RE: Leander Independent School District Draft Habitat Conservation Plan Application
and Draft Environmental Impact Statement

Document Review Comments
Habitat Conservation Plan and Environmental Assessment
For an Access Road to the Leander Independent School District
Vandegrift and Four Point Campus

William A. Conrad CPRM
BCCP Coordinating Committee Secretary

Exhibit A:

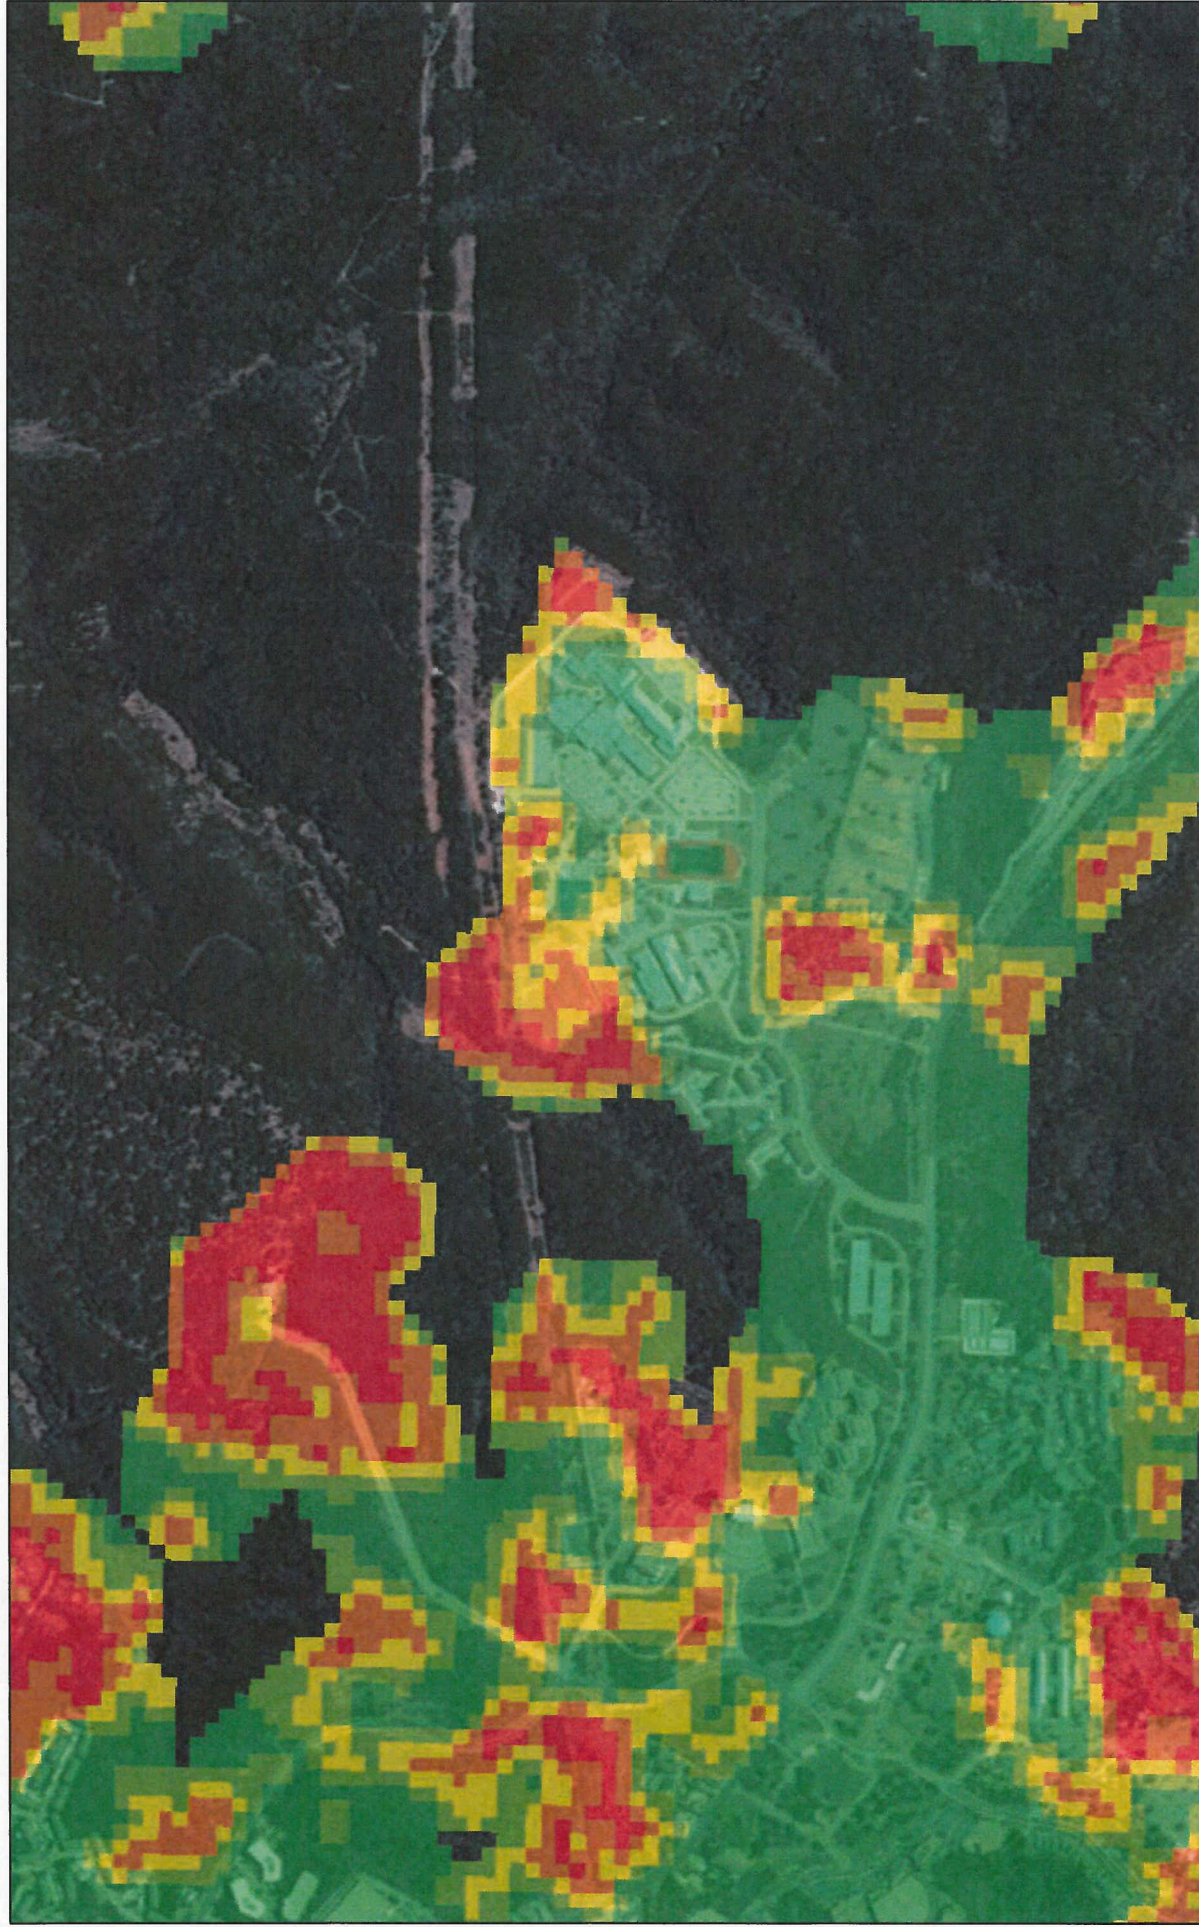
The assertions regarding wildfire risk are not supported by publically available data. In November 2014 the Austin Travis County Community Wildfire Protection Plan (CWPP) was accepted by Austin and Travis County. The CWPP specifically evaluated wildfire risk associated with the LISD campuses that the proposed action is intended to support (exhibit A). Risk for these campuses was generally rated as low or lowest for both radiant heat risk and spotting, except for areas near athletic fields on the northwest side of the campuses. Furthermore, the proposed road alignment traverses areas with wildfire risks rated as high or highest, thus placing road users at more extreme risks from using the road than they would experience at the LISD campuses. Creating and operation of the proposed road would also introduce ignition risks to areas that do not have those risks today where the wildfire ignition potential is rated high by the CWPP.
